TRANSIT EFFECTIVENESS PROJECT Responses to Comments

**City and County of San Francisco Planning Department
Case No. 2011.0558E**

DATE: March 13, 2014
TO: Members of the Planning Commission and Interested Parties
FROM: Sarah B. Jones, Environmental Review Officer
Re: **Attached Responses to Comments on Draft Environmental Impact Report Case No. 2011.0558E Transit Effectiveness Project**

**RESPONSES TO COMMENTS
TRANSIT EFFECTIVENESS PROJECT
PLANNING DEPARTMENT CASE NO. 2011.0558E**

(New) FIGURE 8a - TTRP.L TARAVAL STREET AND 44TH AVENUE IMPROVEMENTS

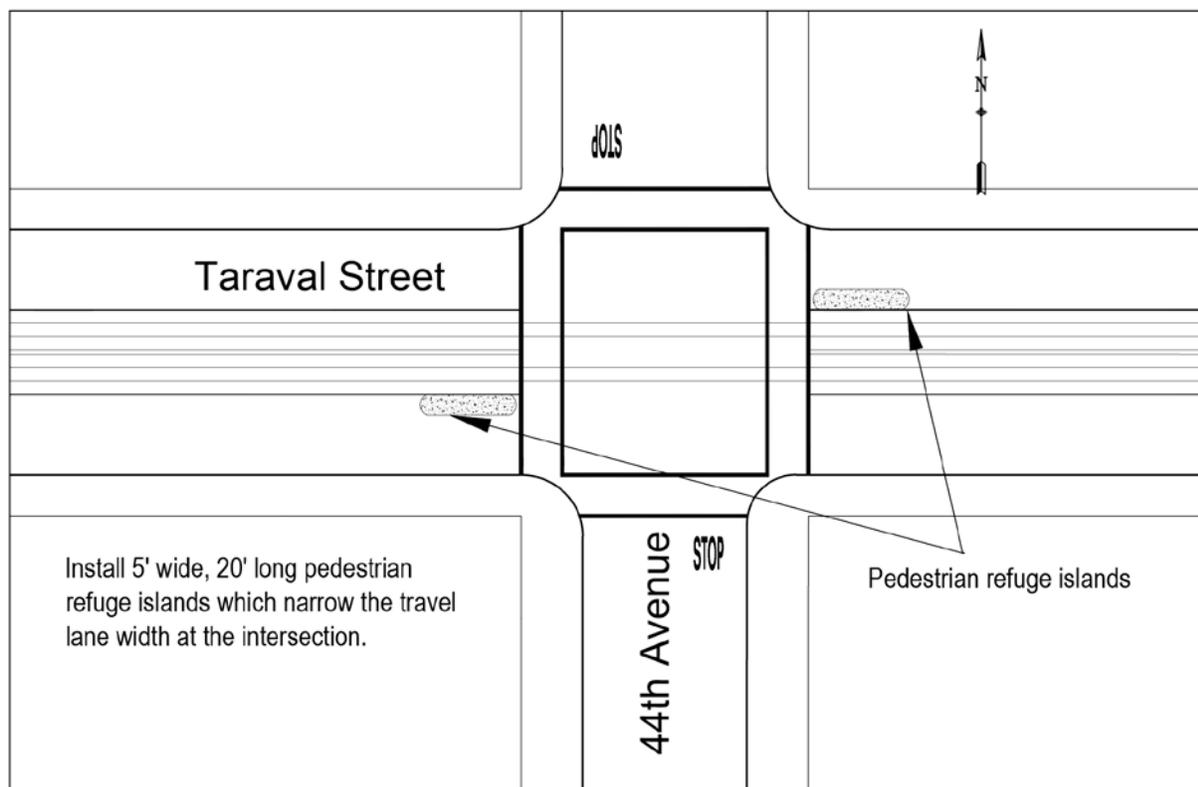
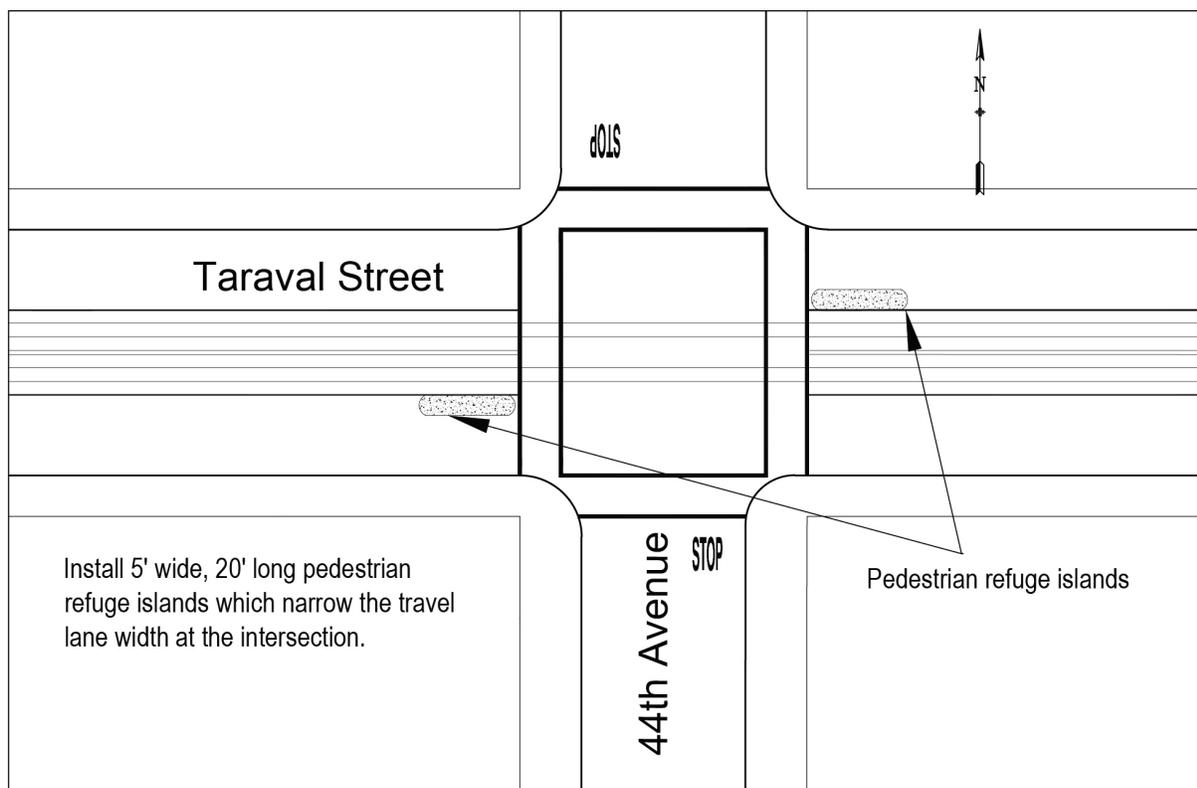
Pedestrian Improvements (Moderate): On Taraval Street at 44th Avenue, a five-foot-wide, 20-foot-long pedestrian refuge island would be added between the mixed-flow travel lane and the transit-only lane in the inbound and outbound directions. Figure 8a shows the proposed change.

(New) **FIGURE 8b - TTRP.L TRAFFIC CALMING AT ULLOA STREET AND 15TH AVENUE EXPANDED ALTERNATIVE**

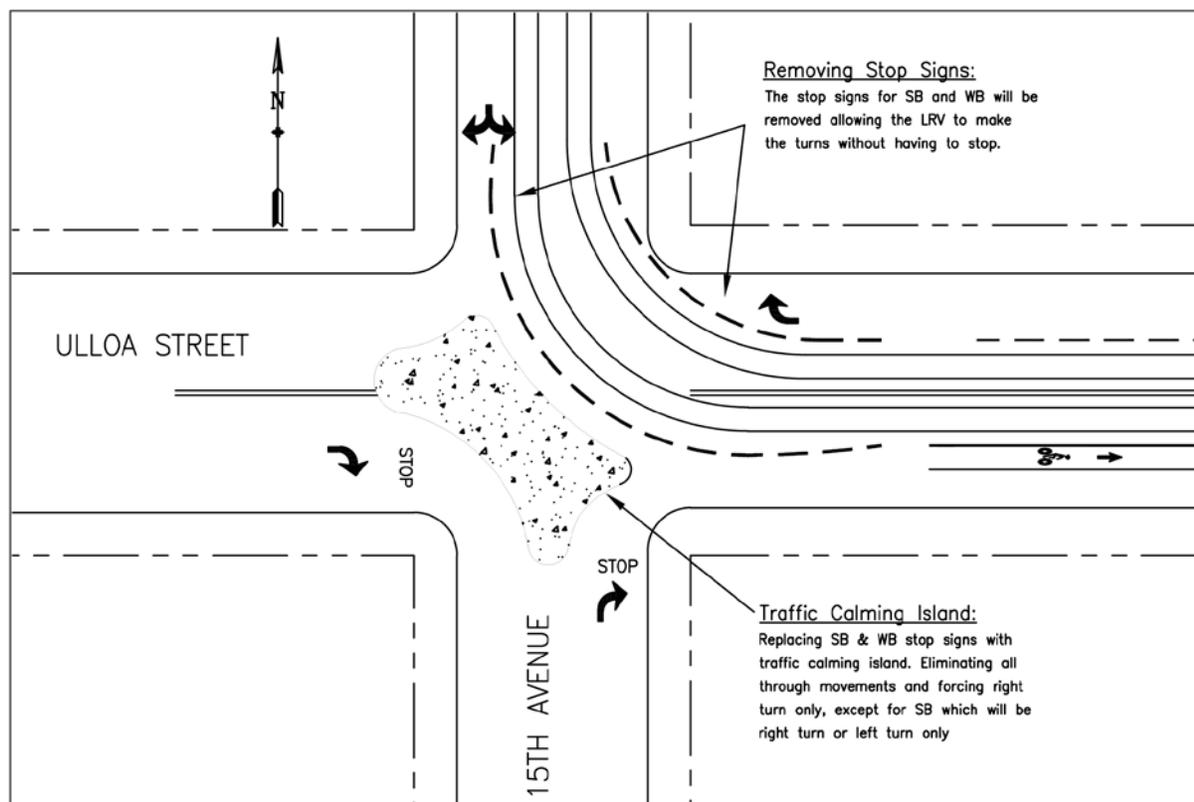
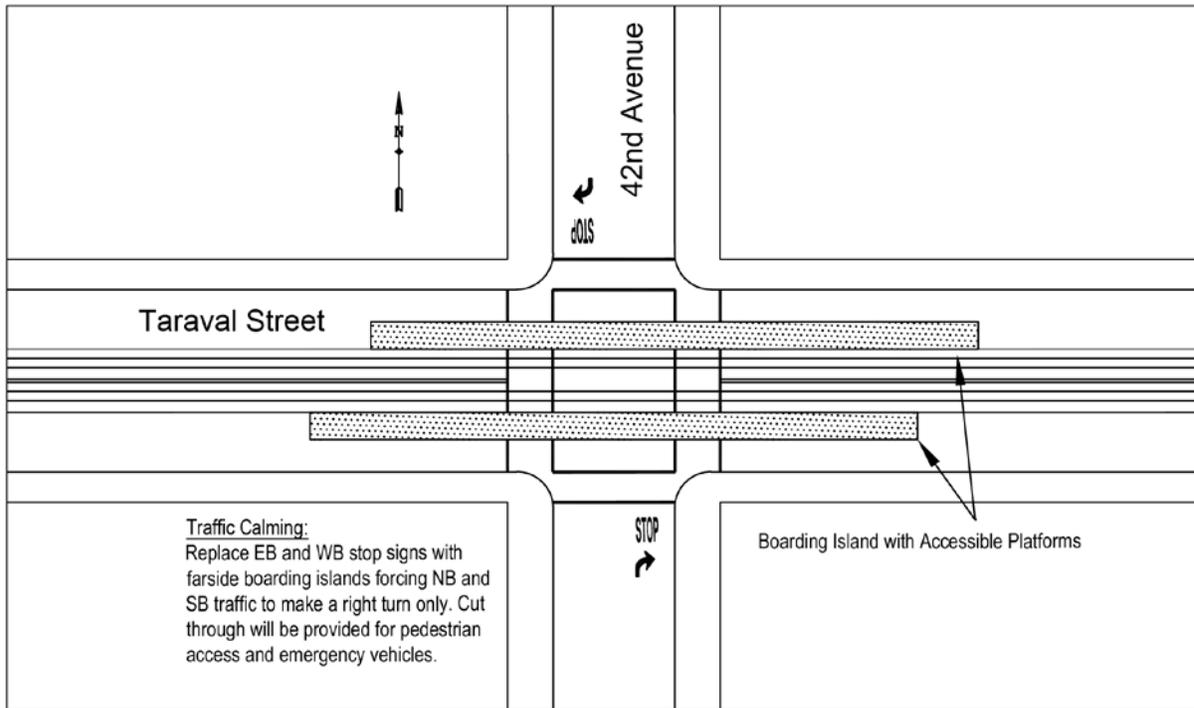
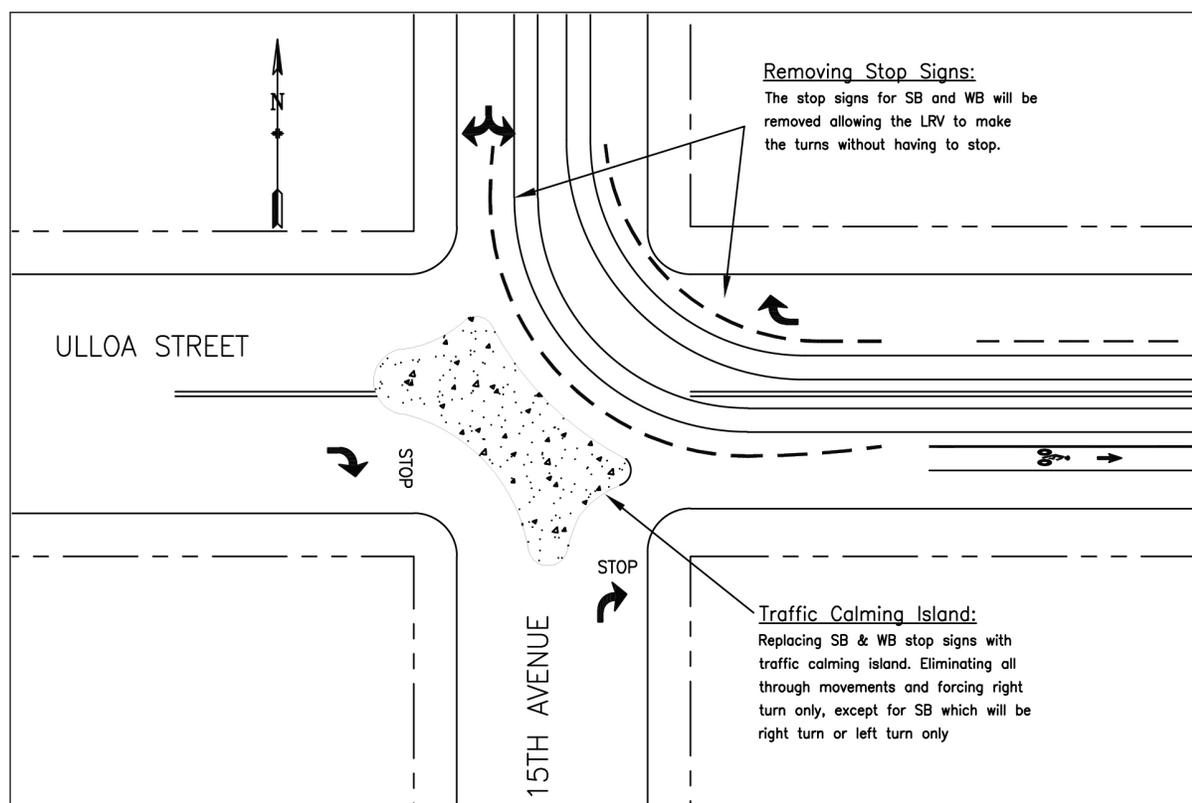
Ulloa Street/15th Avenue: A traffic calming, channelizing island would be added in the intersection which would eliminate all through movements forcing a right turn only for all directions, except for southbound traffic, which would be required to make either a right turn or left turn. Figure 8b shows the proposed change for this intersection.

(New) FIGURE 8d - TTRP.L EXPANDED ALTERNATIVE

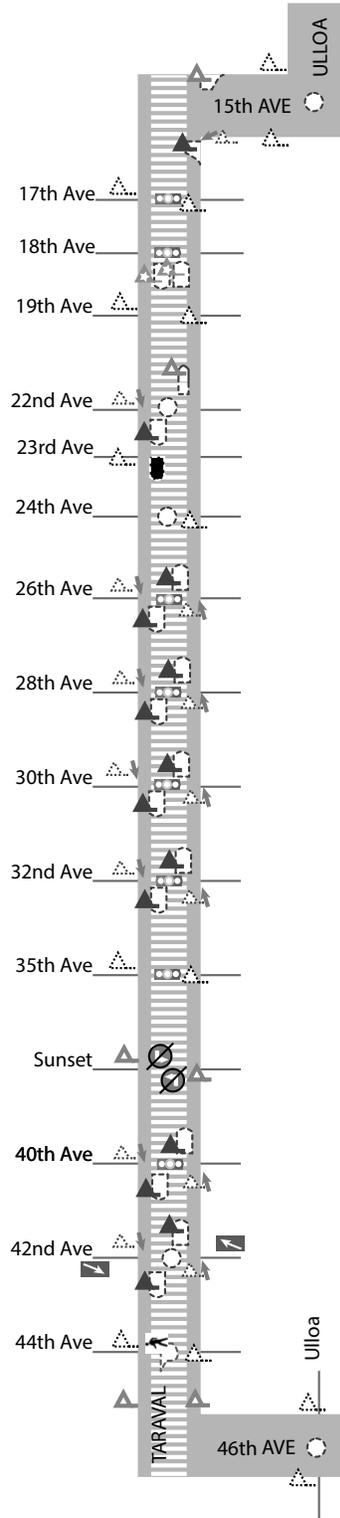
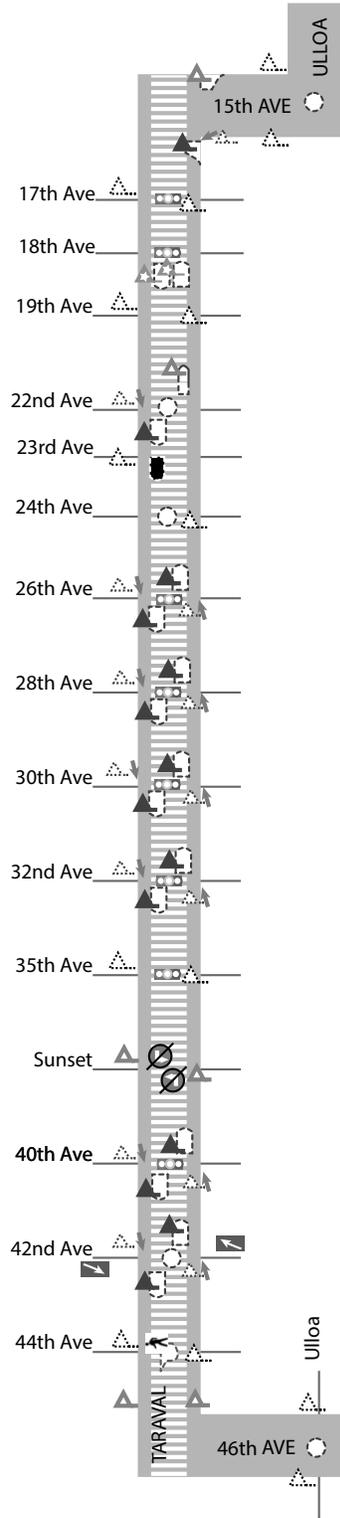
Figure 8d shows the TTRP.L Expanded Alternative and narrative text describes the difference between the Moderate and Expanded Alternatives.

(Revised) FIGURE 11 - TTRP.5 EXPANDED ALTERNATIVE

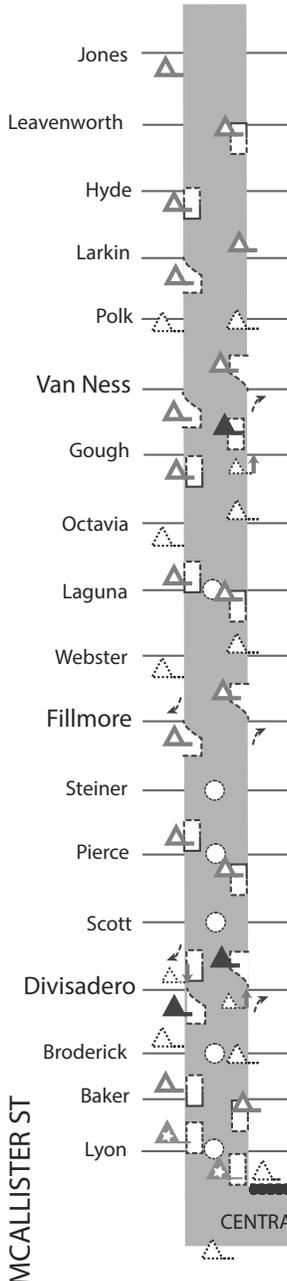
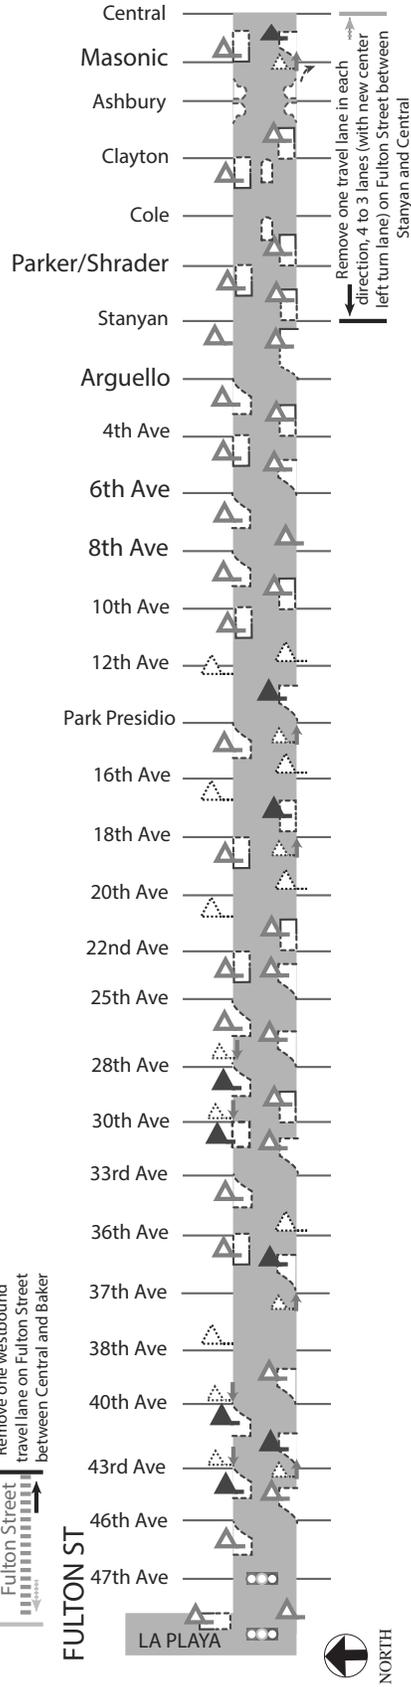
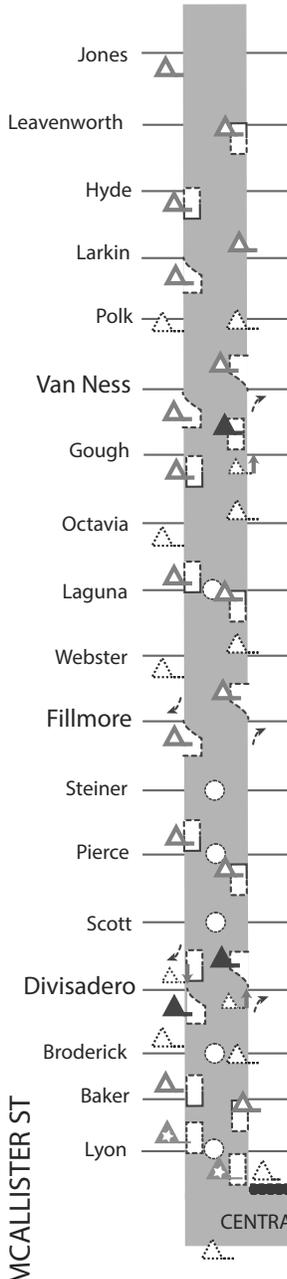
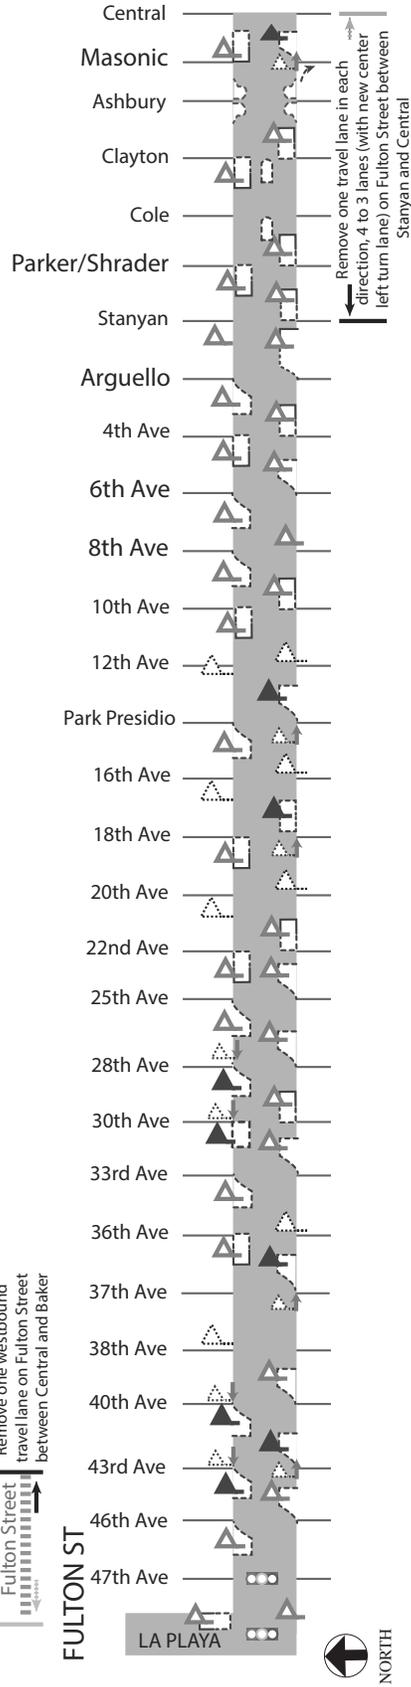
Figure 11: TTRP.5 Expanded Alternative on EIR p. 2-128 has been revised to show that under the Moderate and Expanded Alternatives new inbound and outbound stops would be located at McAllister and Lyon streets, and that one westbound travel lane on Fulton Street (between Central Avenue and Baker Street) would be removed as part of the Expanded Alternative only. Additionally, text on the figure describing how the Moderate Alternative would differ from the Expanded Alternative has been revised to indicate the following: the existing inbound and outbound bus stops at McAllister and Divisadero streets would remain nearside and would be expanded, and right-turn pockets would not be added to McAllister Street at Divisadero Street. Revised Figure 11 is shown on the following page.

(New) FIGURE 14a - TTRP.9 POTRERO AVENUE COMMON INTERSECTION DESIGN ELEMENTS, 17TH TO 25TH STREETS MODERATE AND EXPANDED ALTERNATIVES

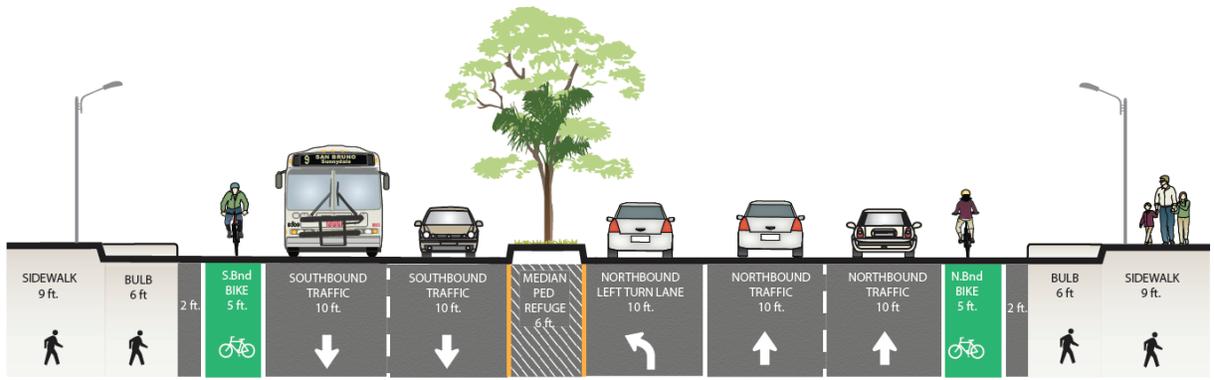
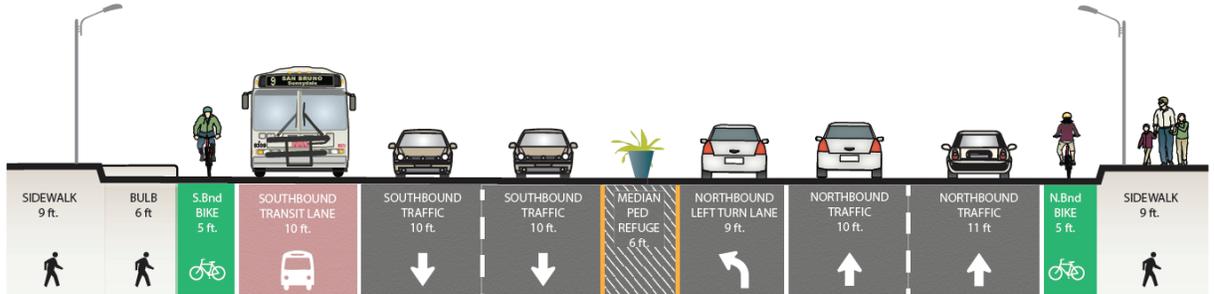
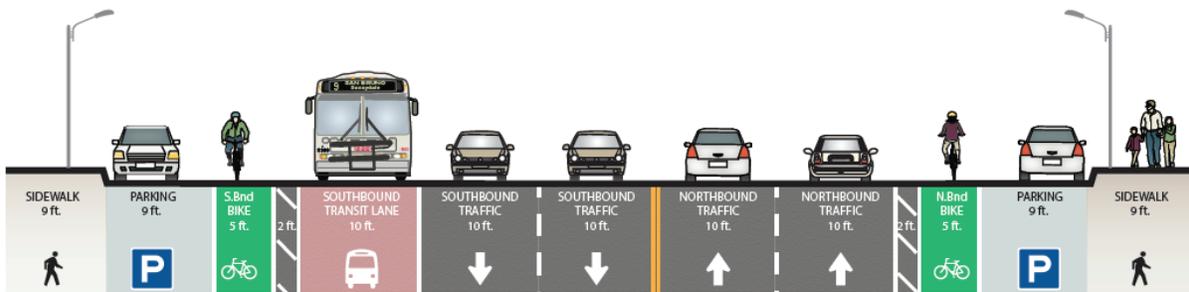
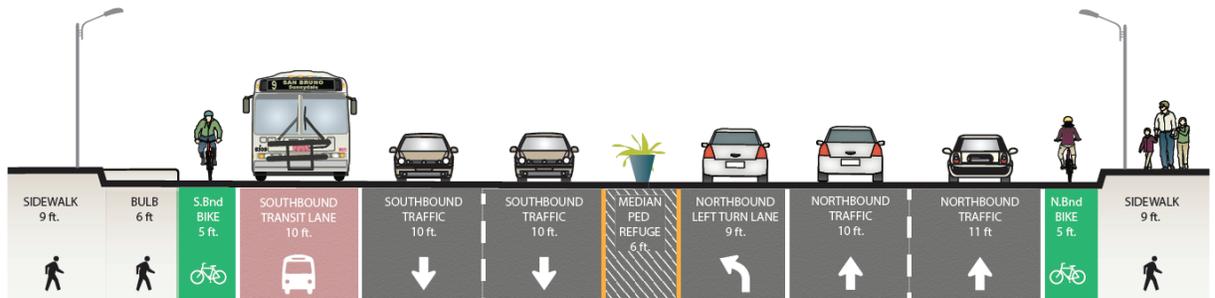
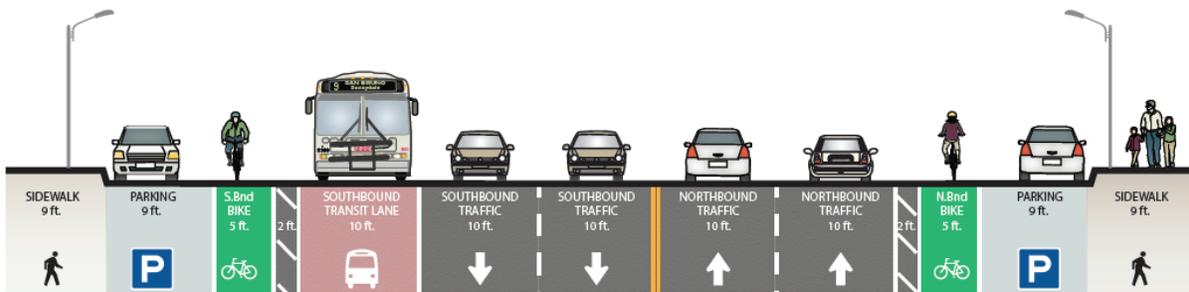
Figures 14a and 14b present the common design elements on Potrero Avenue between 17th and 25th streets for the Moderate and Expanded Alternatives for the intersection and midblock locations, respectively. Figures 14c and 14d present the typical block cross-section at the intersection and midblock on Potrero Avenue between 22nd and 24th streets for the TTRP.9 Moderate Alternative and TTRP.9 Expanded Alternative, respectively.^[fnC]
